Project: GOLDEN GATE BEAUTIFICATION, M.S.T.U.
Project Manager: Darryl Richards, r.l.a., C.C.P.S.D. – A.T.M. Dept.
Consultant: McGee & Associates
Contractor: Hannula Landscaping & Irrigation Inc.
Report Period: May 2013

Report No.: Eight
C - Indicates items to be addressed by Contractor

GOLDEN GATE BEAUTIFICATION, M.S.T.U.

GG MSTU Sunshine Blvd. Well Annual Water Use for 2013

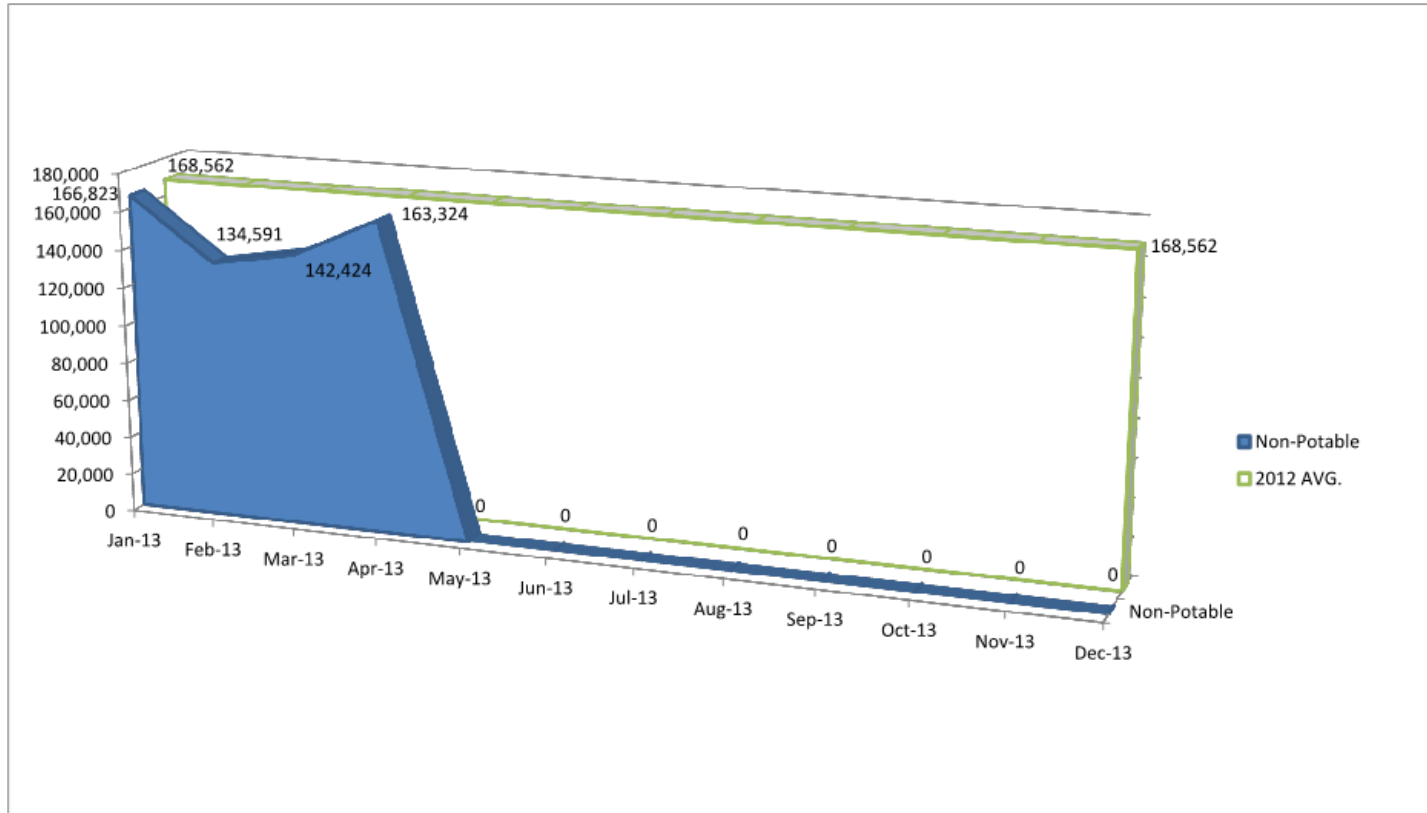
Water Use Goal:

(1.47 ac. of Plants & Turf)

Recommended: Supplemental watering rate of .75 to 1 inch per week. One inch per week equals 39,917 gallons per week or 159,668 gallons per month.

2012 total water use: 2,022,743 gallons or 50.67 inches of supplemental water pumped.
